## TABLE 3.3.7.1-1 (Continued)

RADIATION MONITORING INSTRUMENTATIONACTION STATEMENTS

8804140008 880406  
PDR ADDCK 05000387  
P DCD

# FIGURE 1

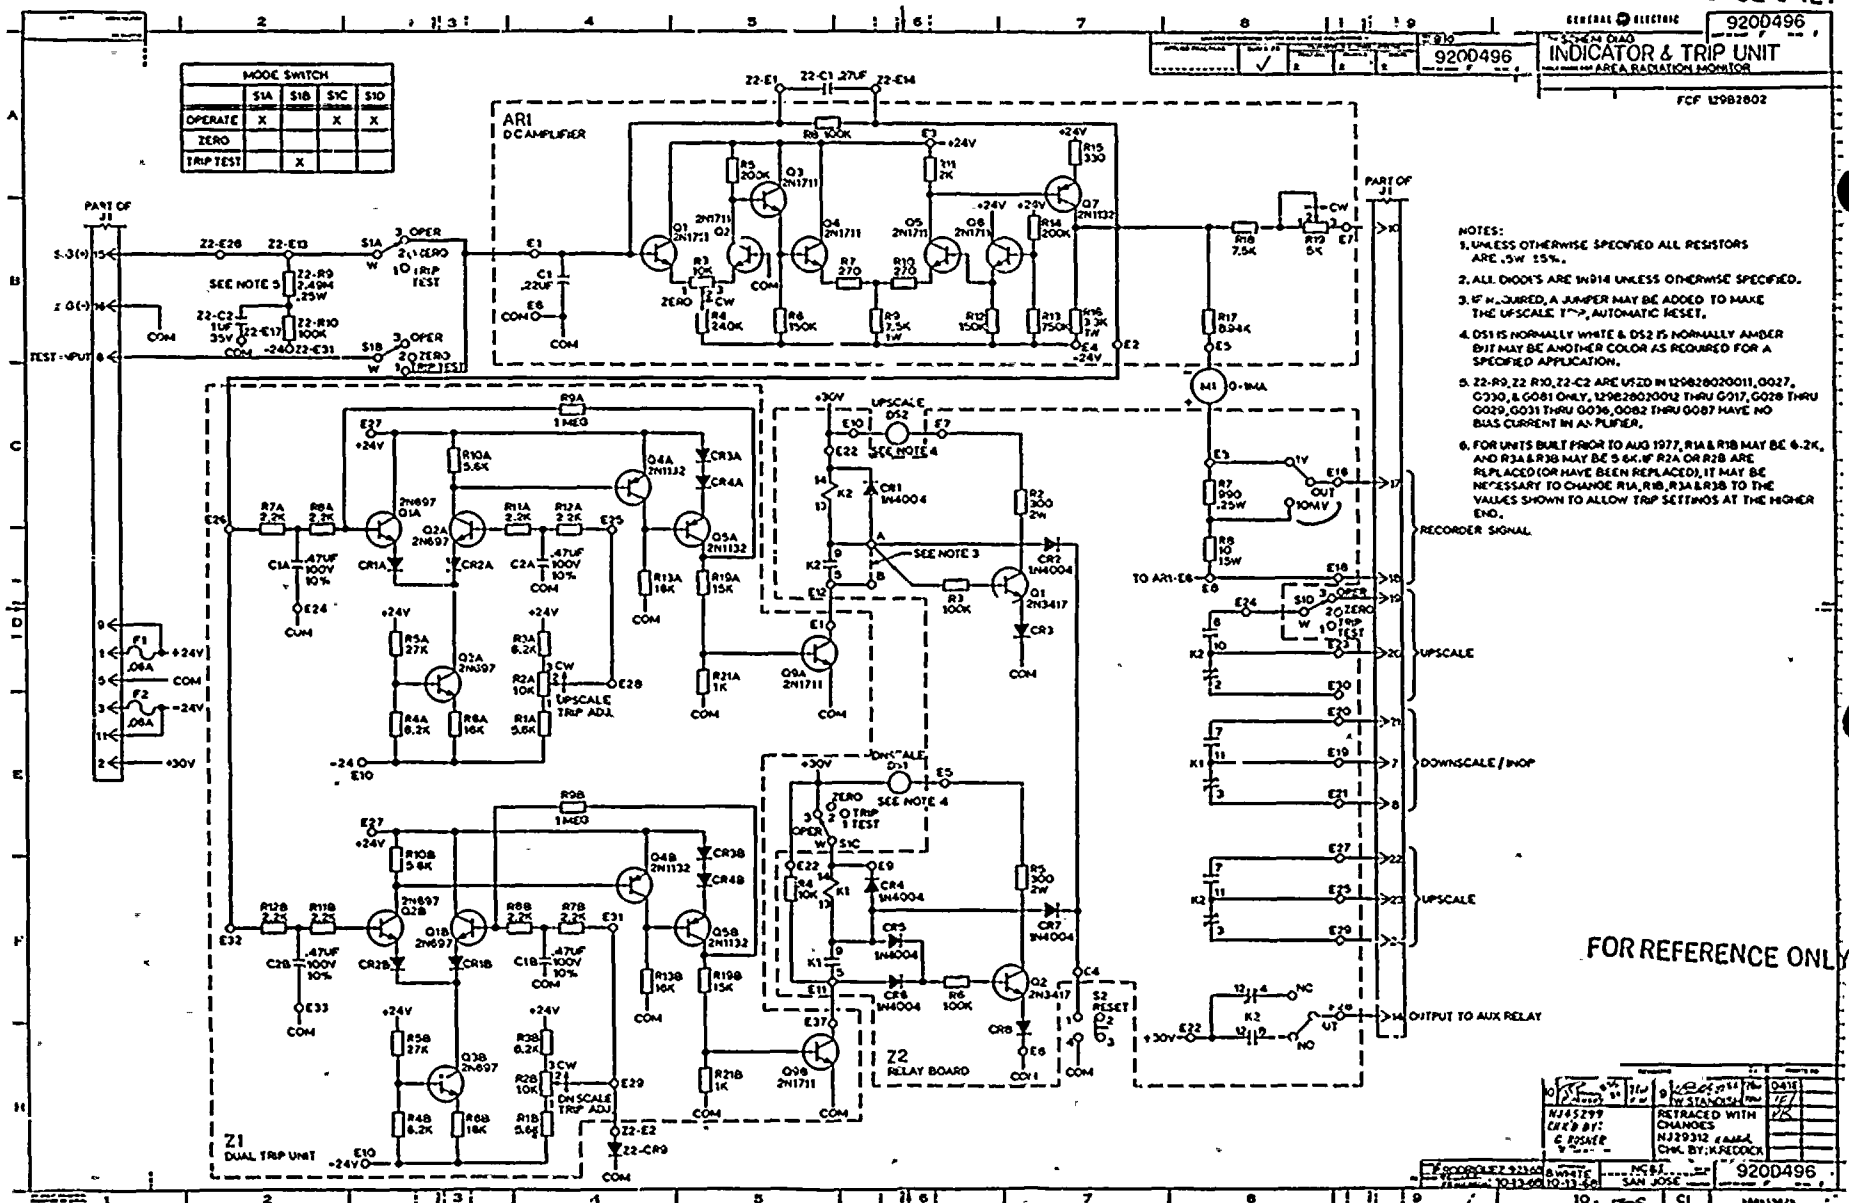
- ACTION 70 -
- a. With one of the required monitors inoperable, ~~place the inoperable channel in the downscale tripped condition within 1 hour;~~ restore the inoperable channel to OPERABLE status within 7 days, or, within the next 6 hours, initiate and maintain operation of the control room emergency filtration system in the isolation mode of operation.
  - b. With both of the required monitors inoperable, initiate and maintain operation of the control room emergency filtration system in the isolation mode of operation within 1 hour.
- ACTION 71 - With the required monitor inoperable, assure a portable continuous monitor with the same alarm setpoint is OPERABLE in the vicinity of the installed monitor during any fuel movement. If no fuel movement is being made, perform area surveys of the monitored area with portable monitoring instrumentation at least once per 24 hours.
